Product Bulletin # TDS-232 Rev 1

Broken Counterbalance Cylinder Cap Screw

Figure 1: HCI/S and ECI/S top drives counterbalance cylinder cap screws

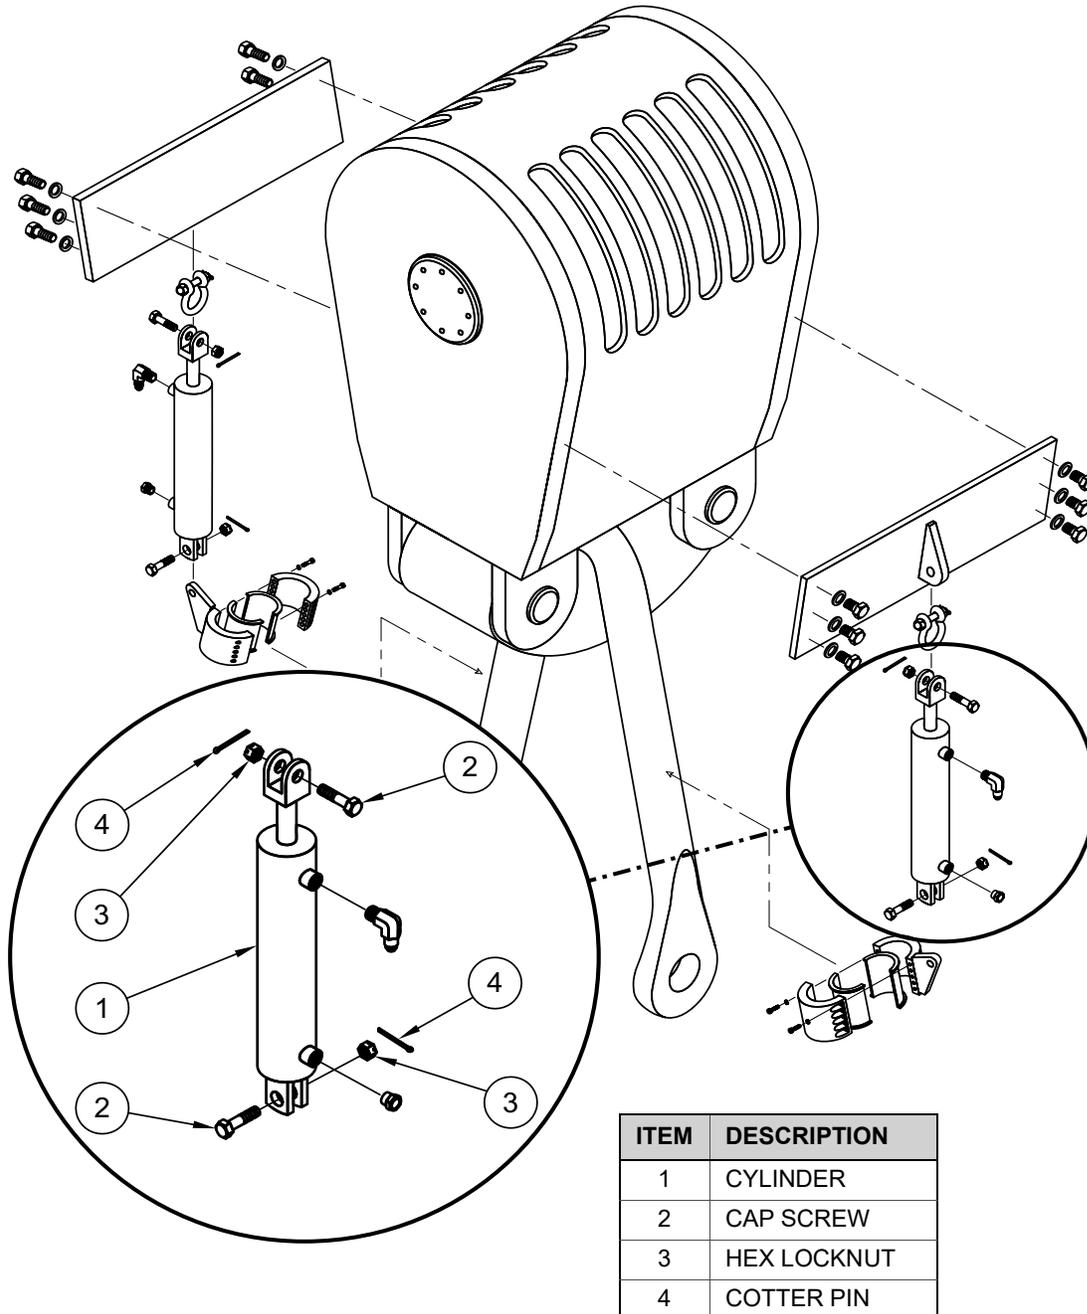
In a recent dropped object incident, a cap screw used in the clevis ends of the top drive counterbalance cylinders broke and dropped to the rig floor. The cap screw broke in half at the root of the thread and fell to the floor. The failure is attributed to the use of cap screws that were too short. The length of the cap screws was such that it was loaded on the threaded section, rather than the unthreaded shank of the cap screw. A longer cap screw would have the unthreaded shank area of the cap screw contacting both sides of the clevis ends of the counterbalance cylinders.

- Ensure that no thread of the cap screws is visible on the inside of the counterbalance cylinder clevis ends.

- Replace existing fasteners with correct length fasteners. Contact RIGLINE 24/7™ to order these parts.
 - For HCI/S and ECI/S, purchase upgrade fastener kit Canrig Part # 5102283.
 - For HXI, purchase upgrade fastener kit Canrig Part # 5102284.
- Perform detailed visual inspection of these fasteners, to look for damage/cracks on the cylinders cap screws every 60 days. Replace if damage is suspected.
- Replace cylinder fasteners at every 250 day inspection.
